CALIFORNIA ENERGY COMMISSION

NOTIFICATION OF APPROVAL
OF STANDARD U-FACTOR DATA
FOR WOOD FRAMED ATTIC ROOFS
WITH INSULATION THAT
COMPLETELY COVERS THE CEILING JOIST

Table IV.1b – U-factors of Wood Framed Attic Roofs
With Insulation That Completely Covers The Ceiling Joists¹

Figure IV.1b – Wood Framed Attic Roofs with insulation that completely covers the ceiling joists

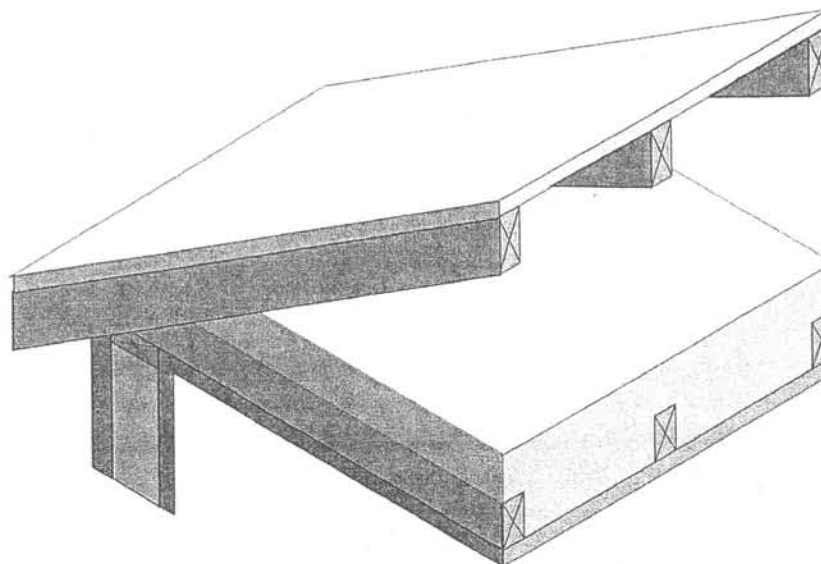
This Notification of Approval, of Standard U-factor Data for Wood-Framed Attic Roofs With Insulation That Completely Covers The Ceiling Joists, authorizes the use of the data shown in the attached Table IV.1b, including the limitations in the description following the table. Table IV.1b is now officially added as an addendum to Joint Appendix IV to replace the existing Table IV.1 and Table IV.1a.

Table IV.1b shall be used only when insulation is placed over and completely covers the ceiling joists of wood framed attic roofs. If insulation is placed between the ceiling joists of wood framed attic roofs, but not over and completely covering the ceiling joists, then Joint Appendices IV, Table IV.1c shall be used. This table replaces the existing Table IV.1 and Table IV.1a. This table contains thermal performance data (U-factors) for wood framed attics where the ceiling provides the air barrier and the attic is ventilated. This table shall not be used for cases where insulation is located at the underside of the roof. Wood trusses are the most common construction for low-rise residential buildings and for Type V nonresidential buildings. While the sketch shows a truss system with a flat ceiling, the data in this table may be used for scissor trusses and other non-flat trusses. If the bottom of the ceiling joist is not flat, then the slope shall not exceed 4:12 if blown insulation is used. This table may also be used with composite trusses that have a wood top and bottom joist and metal struts connecting them.

For the majority of cases, values will be selected from column A of this table. Column A shall be used for the common situation where either batt or blown insulation is placed directly over the ceiling (and tapered at the edges) in such a manner that the insulation completely covers the ceiling joist. Builders or designers may increase thermal performance by adding a continuous insulation layer at the ceiling below

When this table is used, the R-value of continuous insulation shall be equal to or greater than the R-value published in the continuous insulation columns (columns B through H). For example, if the insulation is R-3, the R-2 column shall be used. No interpolation is permitted when data from the table is selected manually. The California Energy Commission approved ACMs, including those used for prescriptive compliance, may be used to accurately account for any amount of continuous insulation, or for unusual construction assemblies using Equation IV-1 and Equation IV-2.
